**Brattle CONE Combustion Turbine
Revenue Requirements Review**

Monitoring Analytics, LLC

Pasteris Energy, Inc.

July 25, 2014

Figure 1

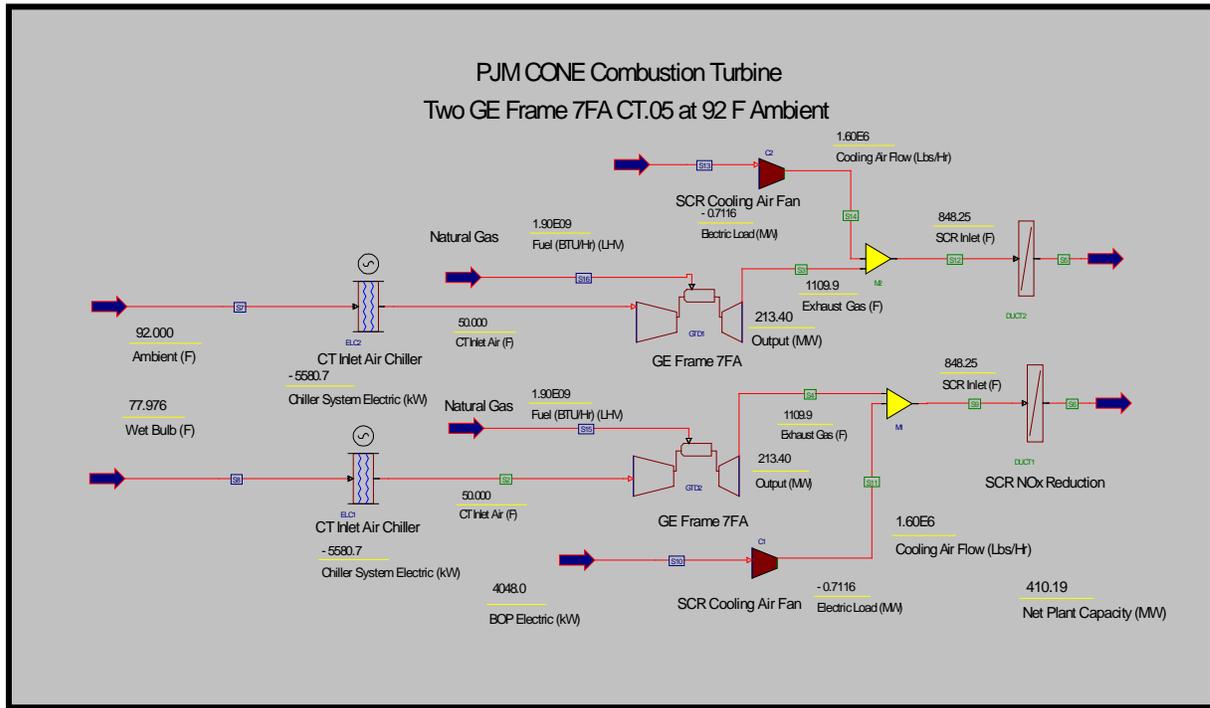
Figure 1 provides details of the Frame 7FA.5 CT plant under ambient conditions of a 92°F dry bulb temperature and a 78°F wet bulb temperature. The net electric capacity of the Frame 7FA.05 CT plant is 410.16 MW. This capacity is net of the chiller system parasitic load of 11.16 MW. Each CT output is 213.40 MW with TIC to 50°F compressor inlet temperature. With evaporative TIC the net electric capacity is 393.41 MW with each CT output at only 198.59 MW at the same ambient conditions. The net plant capacity increase due to mechanical TIC over evaporative cooling is 16.75 MW.

The SOM CONE CT is essentially the same technology and design estimated by Brattle with the exception the Brattle uses CT inlet air evaporative cooling for hot weather power augmentation while the SOM CONE CT uses mechanical CT inlet air chilling (“TIC”) to 50 °F. The net capacity of the Brattle CONE CT power plant is 396 MW at 94 °F and 44.2% relative humidity (76.2 °F WBT) and the net capacity of the SOM CONE CT power plant is 410 MW at a 92 °F dry bulb and 78 °F wet bulb temperature. Pasteris Energy performance modeling results show a 16.75 MW increase in net capacity via TIC over evaporative cooling. Accordingly, the 14 MW difference between the Brattle CONE CT and the SOM CONE CT appears reasonable. Brattle CONE CT and the SOM CONE CT heat rates are very close at 10,309 BTU/kWh (HHV) and 10,241 BTU/kWh (HHV).
